VSP-75

VENDOR SERVICE PUBLICATION

SUBJECT: Avco Lycoming Service Letter No. L218 and Service Instruction  
No. 1059C, No. 1110C and No. 1257E

**DATE:** April 10, 1987  
**Service Instruction No. 1110C**  
(Supersedes Service Instruction No. 1110B)  
**Engineering Aspects are**  
**FAA Approved**

**Typical Adapter Installation**

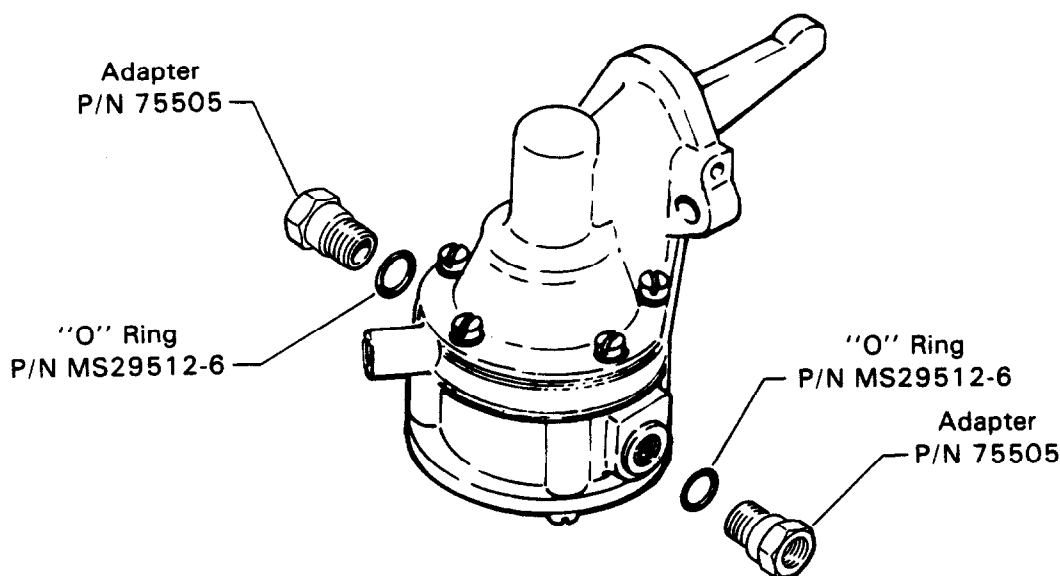
When replacing certain older AC diaphragm type fuel pumps, AC P/N 40174 or P/N 56999 (tapered pipe thread inlet and outlet ports) with a new pump incorporating straight thread ports, an adapter P/N 75505 is available to adapt the pipe thread fittings to the new pump. All newer types of fuel pumps incorporate straight thread ports.

When the older model fuel pumps are replaced with new models, 2 Adapters P/N 75505 and 2 "O" Rings P/N MS29512-6 (one for each adapter) must be ordered separately for proper installation.

**Figure 1.**  
**Carburetor Showing Area to be Machined**

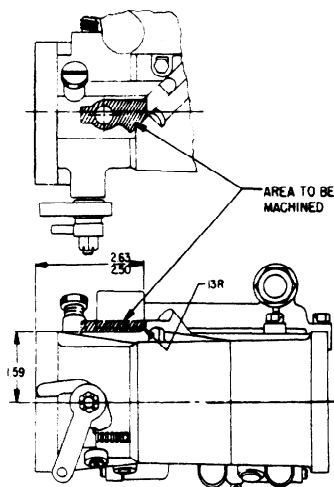
Because of the increased size of the new AC fuel pumps, certain engine models using P/N LW-16335 fuel pump with rear mounted carburetors must have the carburetor reworked to remove the back suction economizer boss. (If not already accomplished or prior to installation of new P/N LW-16335 fuel pump.) See Table 1. Using suitable equipment machine this boss as shown in Figure 1. Also, because of the increased size of the new fuel pump, certain dual magneto engine models must have the accessory housing reworked. See Table 2. Again, using suitable equipment, machine the boss on the accessory housing as shown in Figure 2.
